Canisius High School
Robert J. Stransky Memorial Athletic Complex
Phase Three Development Project
TA Project 20020

Town of West Seneca
Town Hall
1250 Union Road
West Seneca, New York 14224

The following is an update on the progress since our last Planning Board meeting on June 10, 2021:

Canisius High School
LRB 2021-01394
Sheet 3 of 4

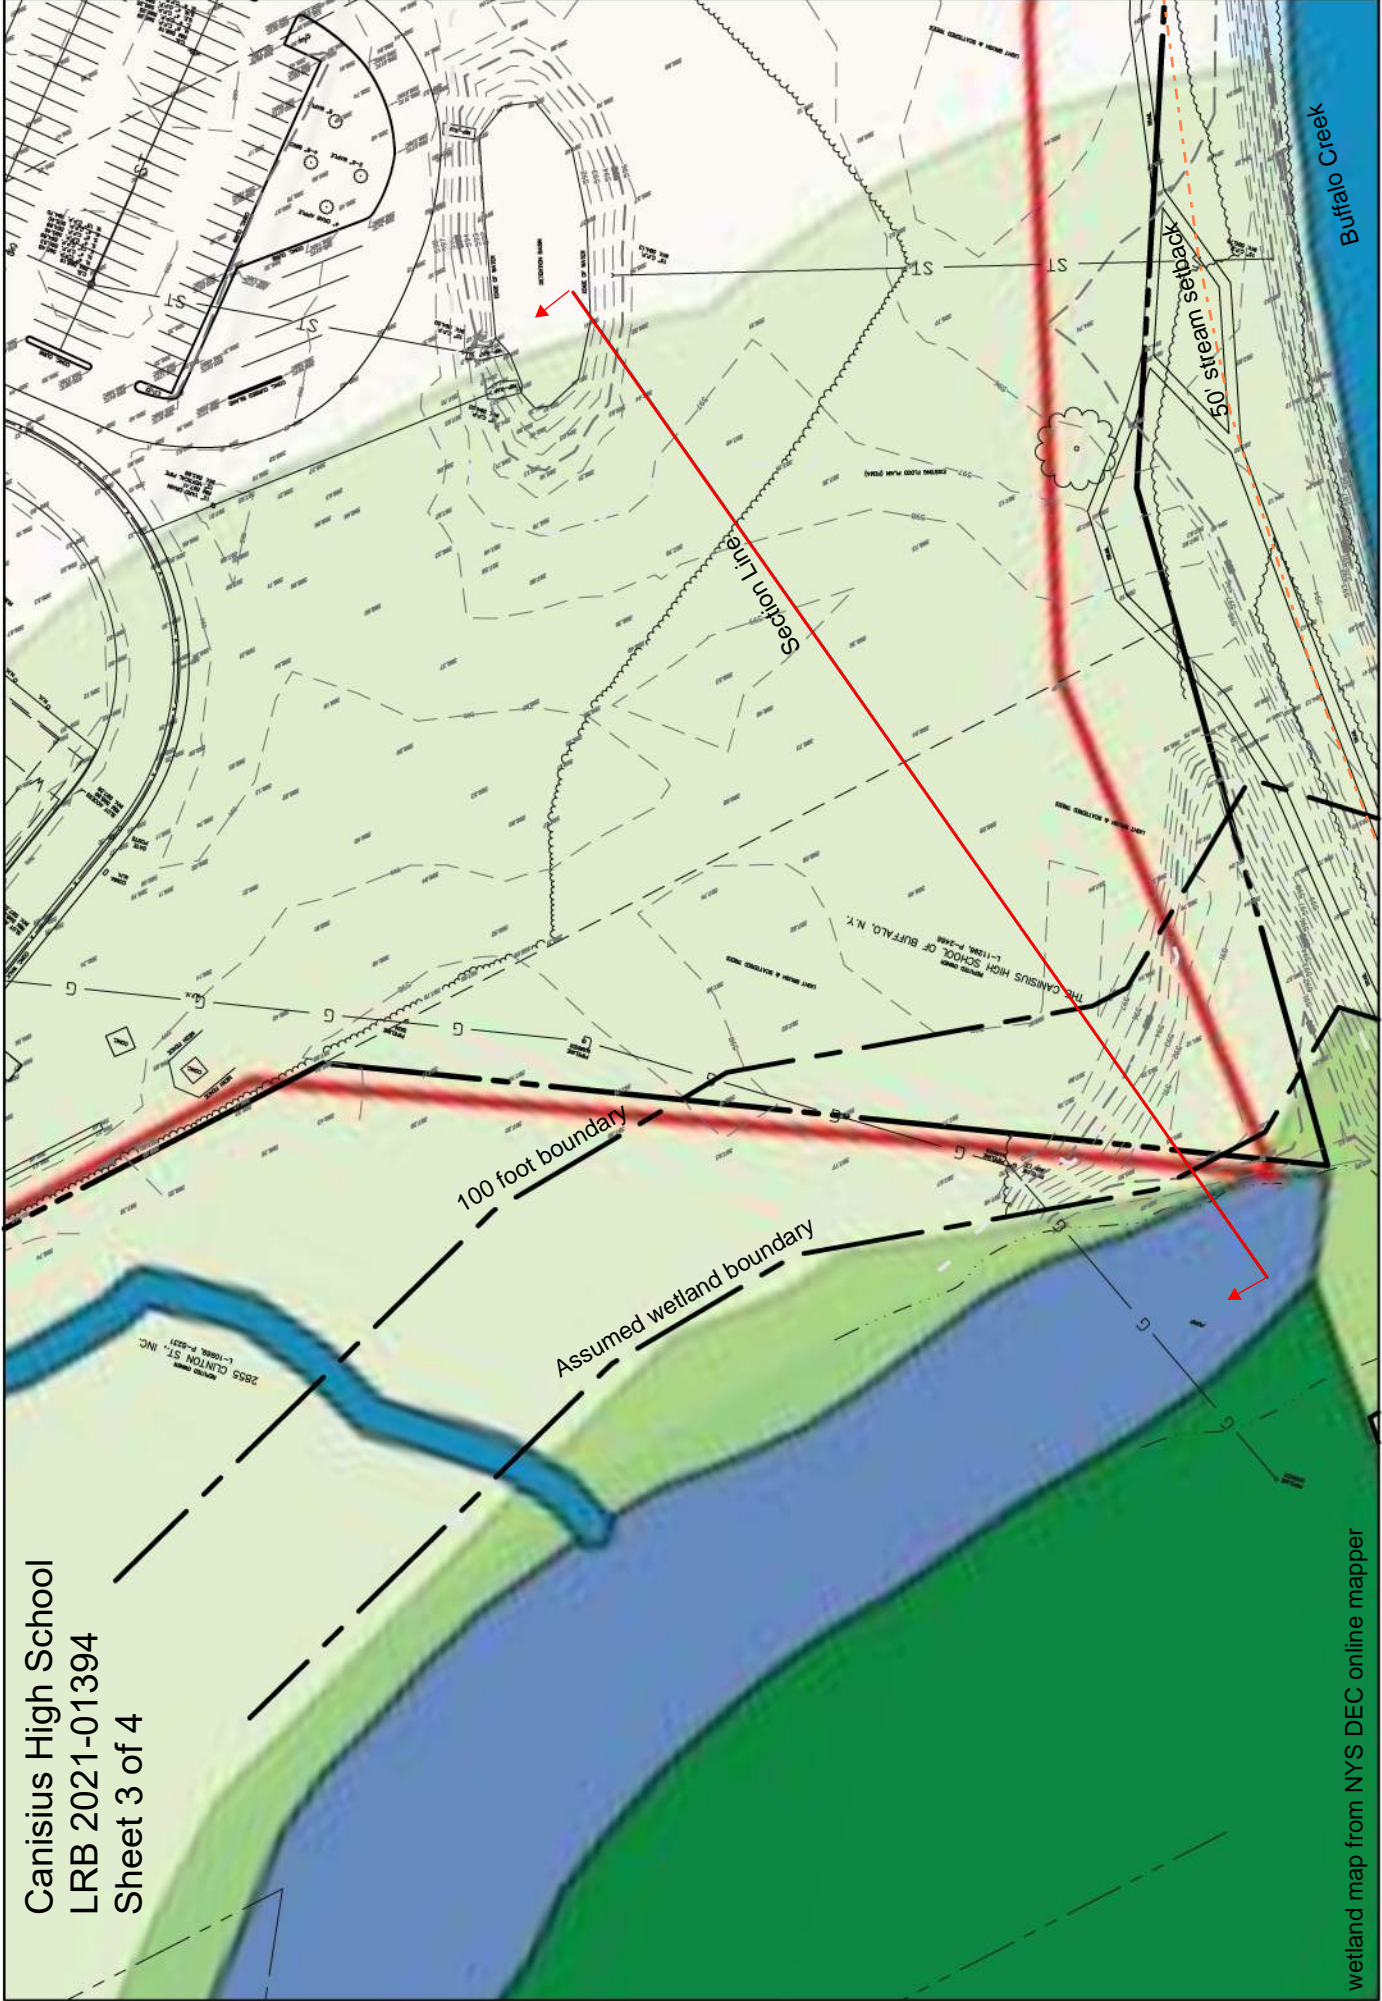
I have determined that the review area as depicted on Figure 3 of 4 is comprised entirely of dry land and contains no potential aquatic resources regulated under Section 404 of the Clean Water Act or Section 10 of the Rivers and Harbors Act of 1899. Therefore, a Department of the Army permit **is not** required for any activities occurring within the review area.

Determination: USACE confirmed that the review area is located within the 100-foot adjacent area and is comprised entirely of dry land. There are no waters or water features, including wetlands, of any kind in the entire review area.

Sheet Number: **C104**

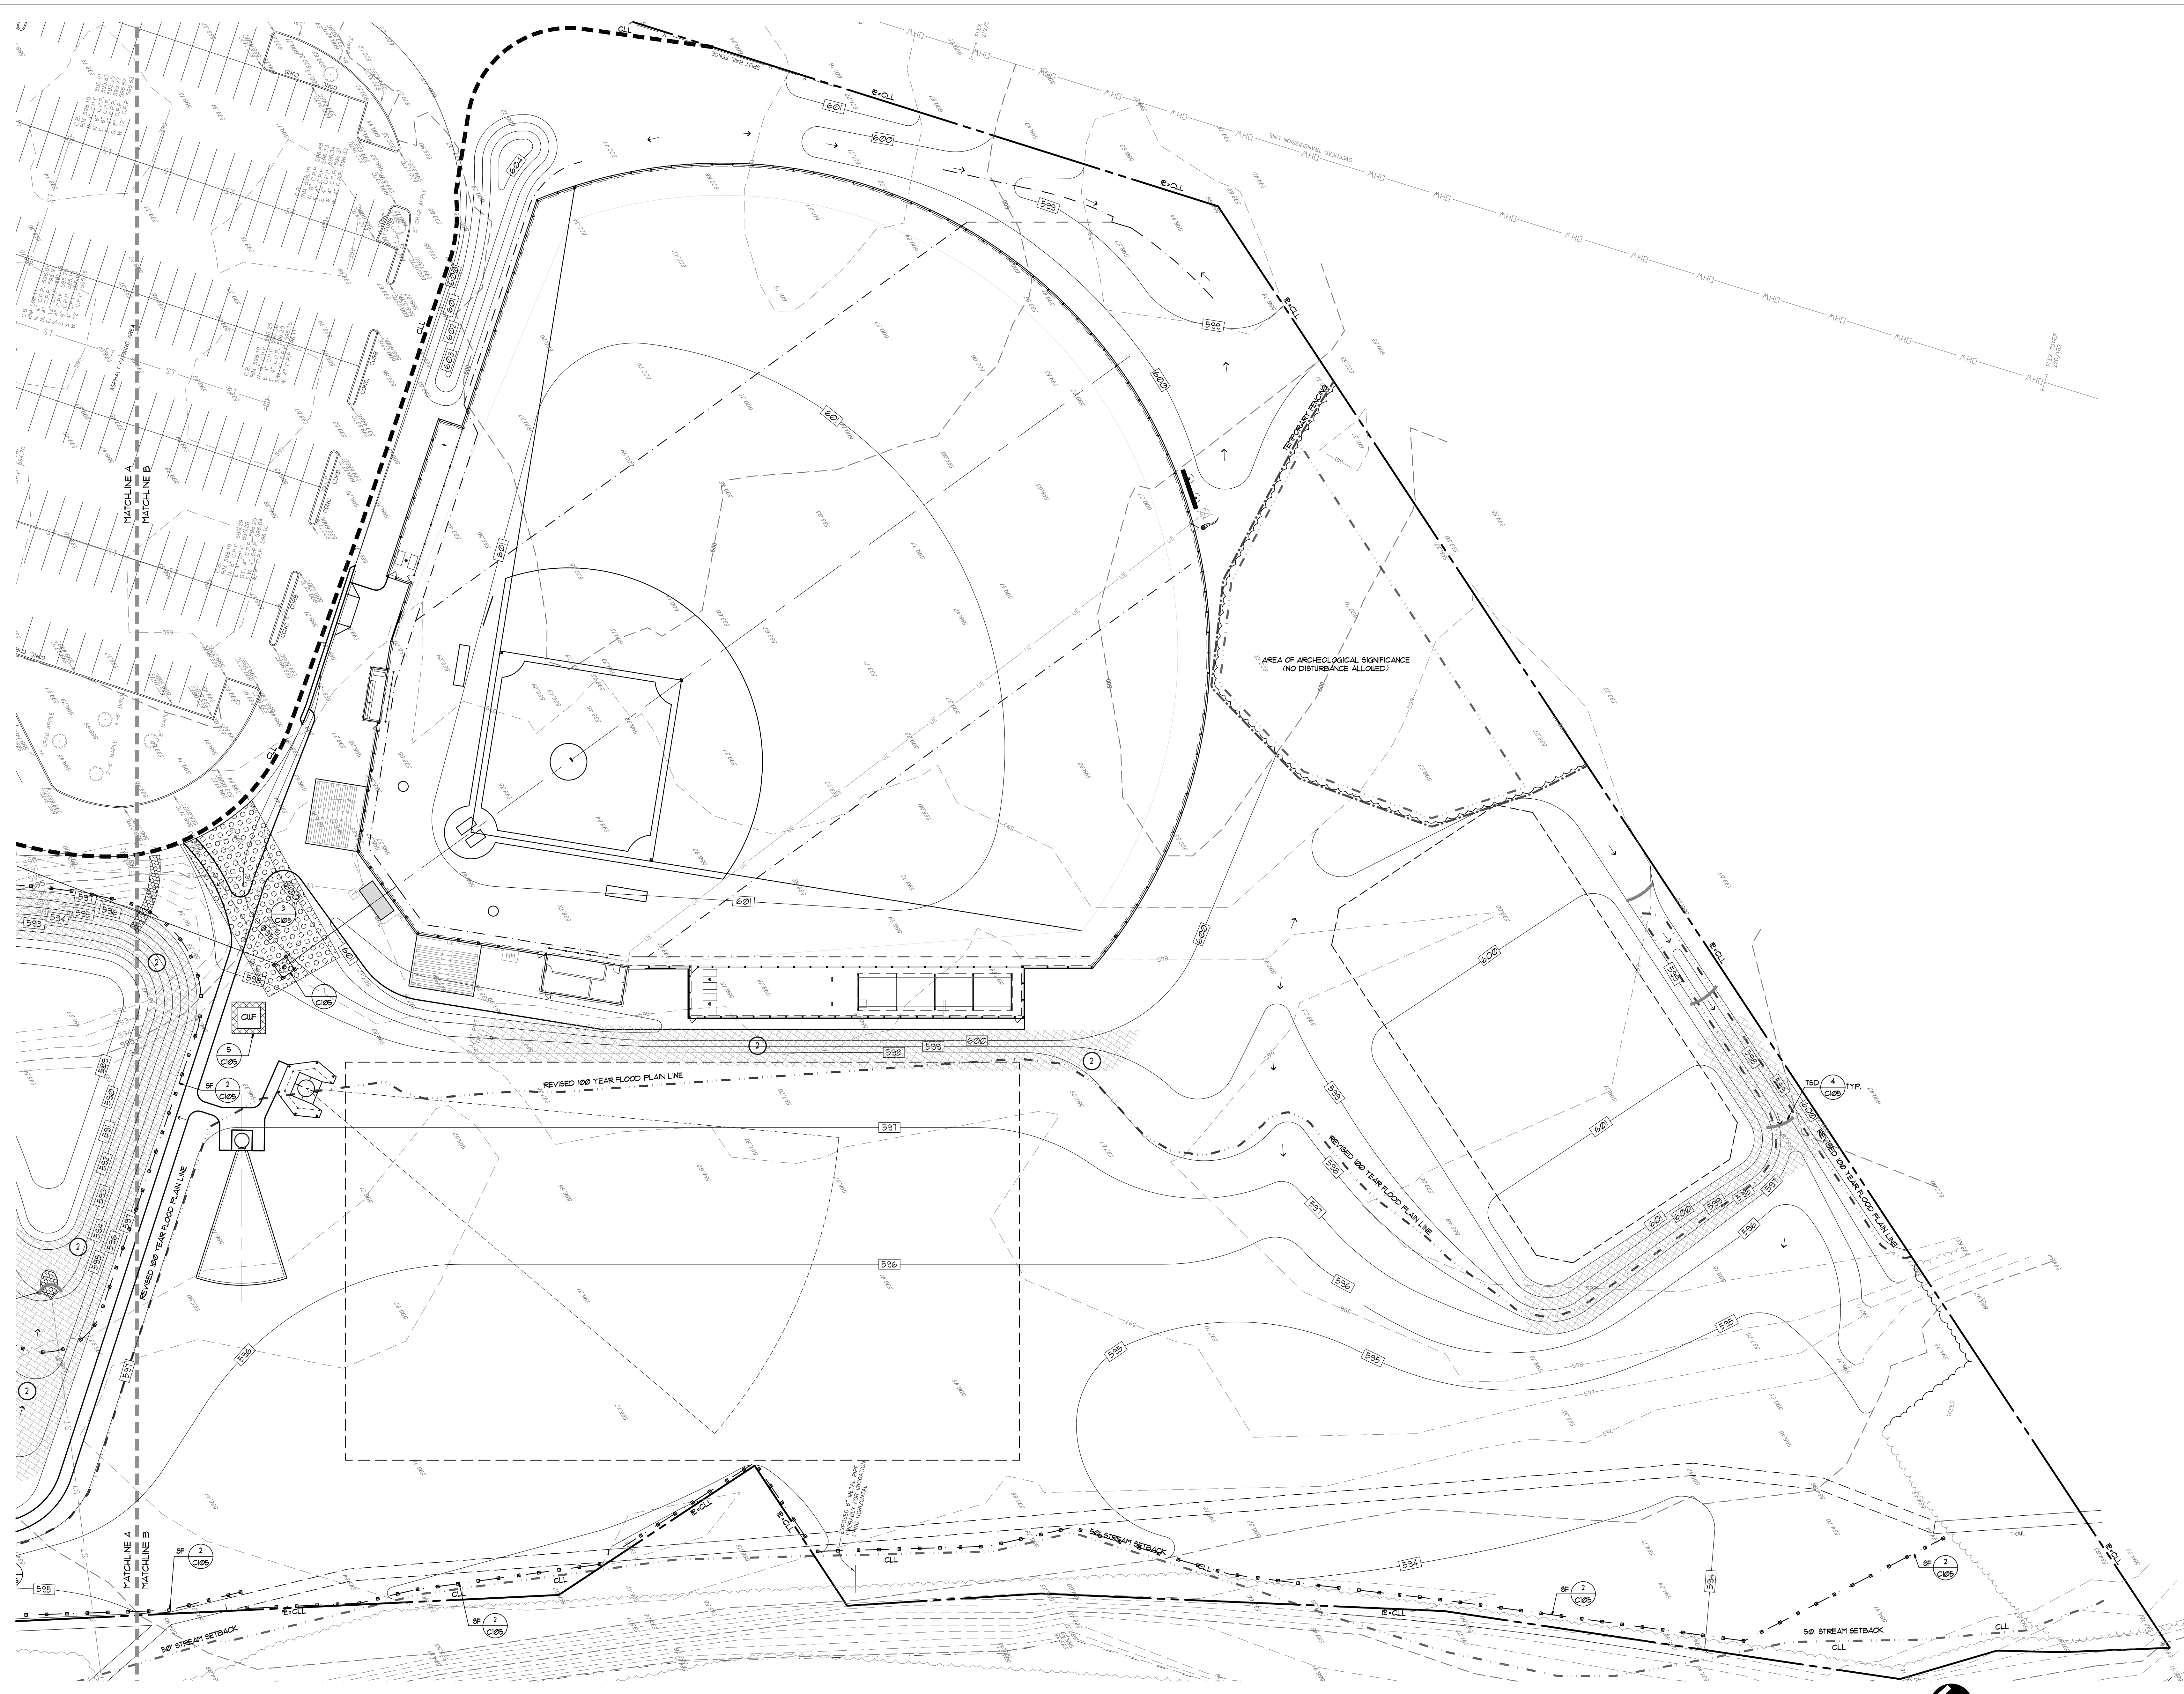
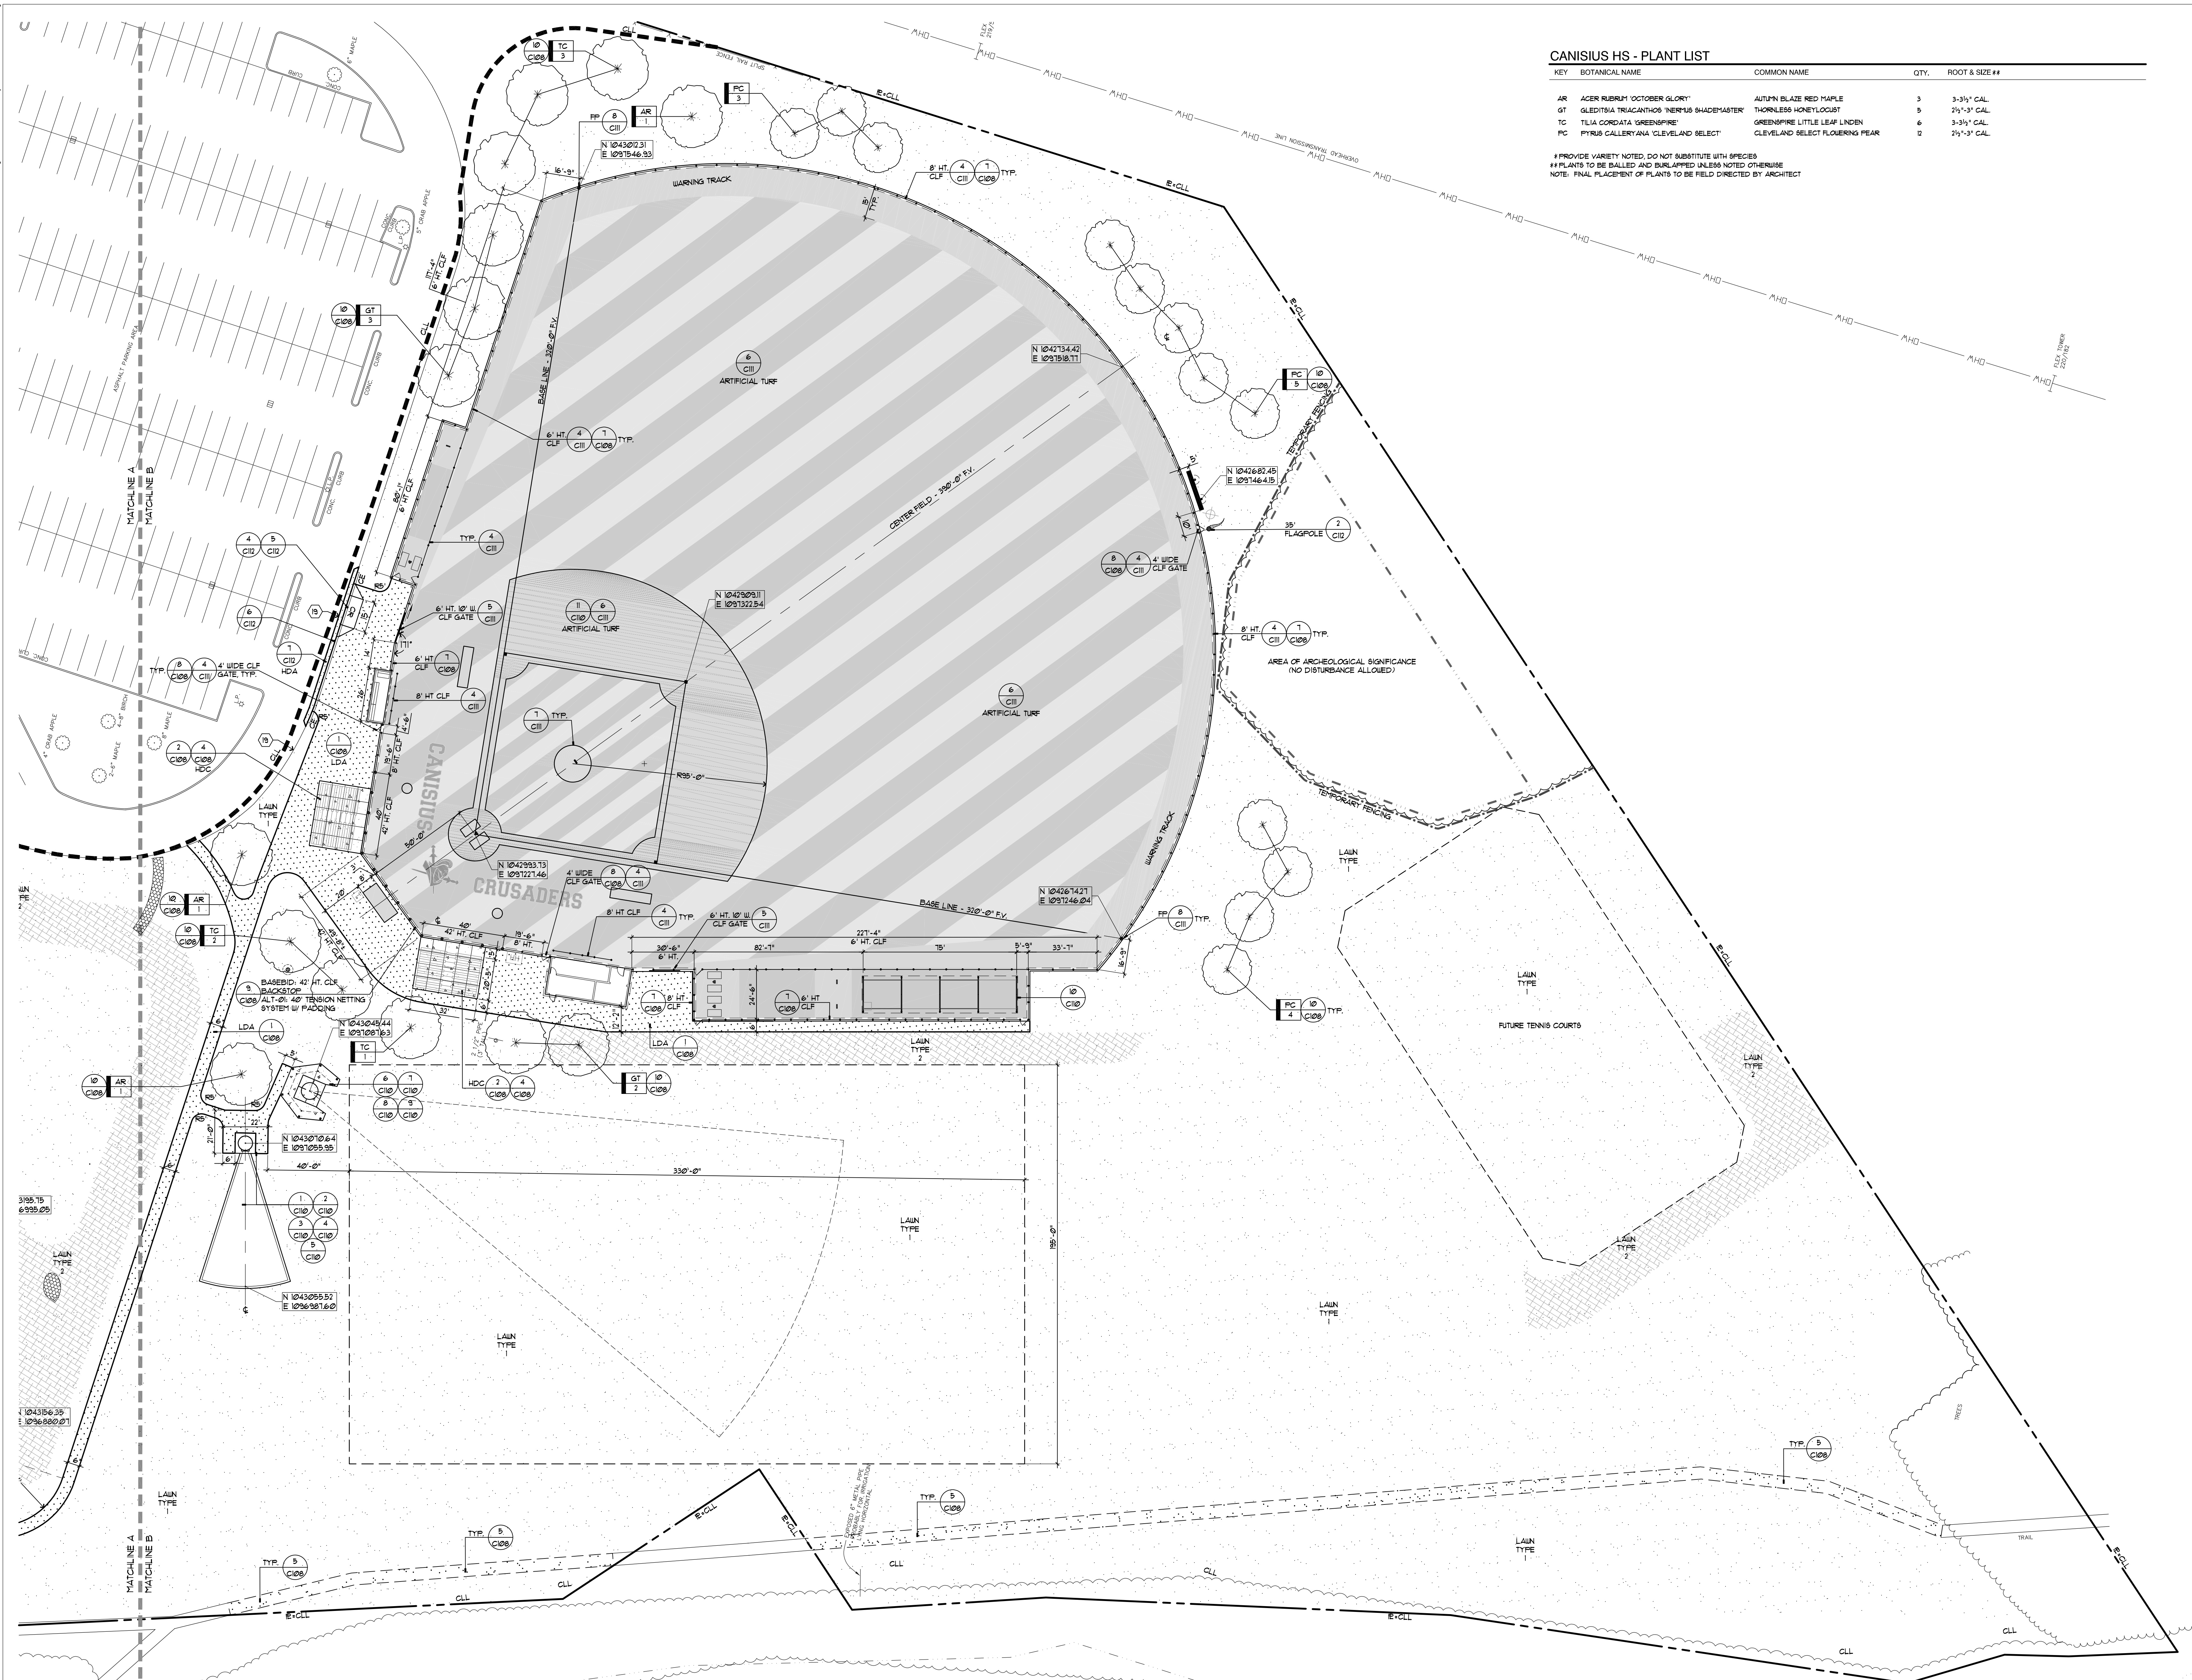
- a. Attached are the updated drawings based on the minor shift of the varsity baseball field location as required by OPRHP.
 - b. This shift reduced the amount of asphalt leading up to the field from the parking lot, however we did not adjust the sizing of the pond to reflect this reduction.

- c. The pond sizing and SWPPP calculations remain as per the original submission as another safety factor for more storage and also this keeps the floodplain calculations not affected by this change.
